PRODUCT / PROCESS CHANGE NOTIFICATION

PCN-000260

SOT25 & SOT26 lead frame material change from EFTEC-64T to CDA194 due to worldwide shortage of EFTEC-64T raw material from Furukawa plant shutdown. Current SOT25/26 lead frame supplier is MHT, adding NBKQ (current supplier of QFN lead frame) as another supplier.

SOT25/26 Material Change Qual Report

PCN of SOT26&26
DF change materi:

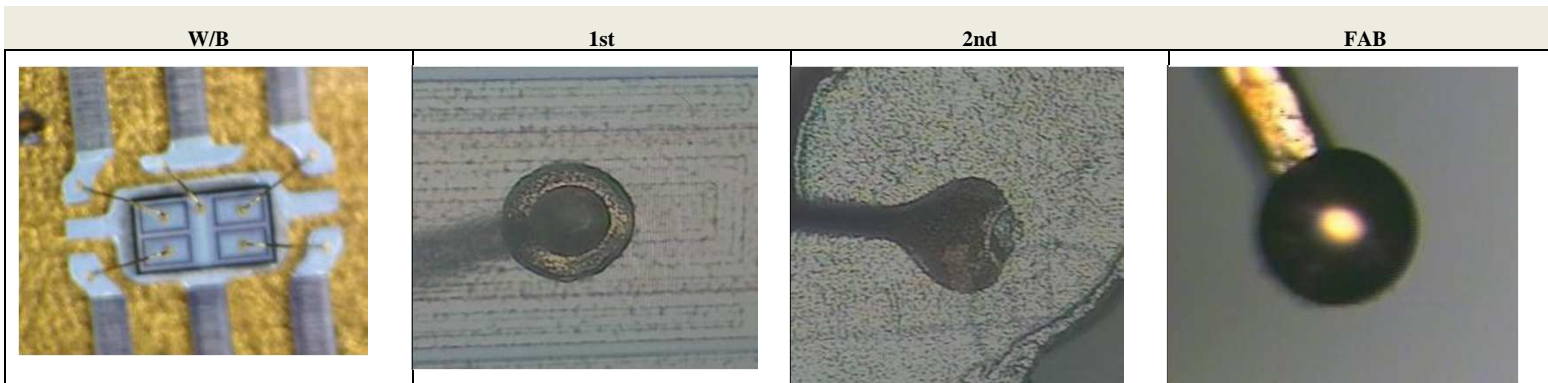
There are 23 SEMTECH devices will be affected (Epoxy process), here is purpose to change the material from EFTEC-64T to CDA194.
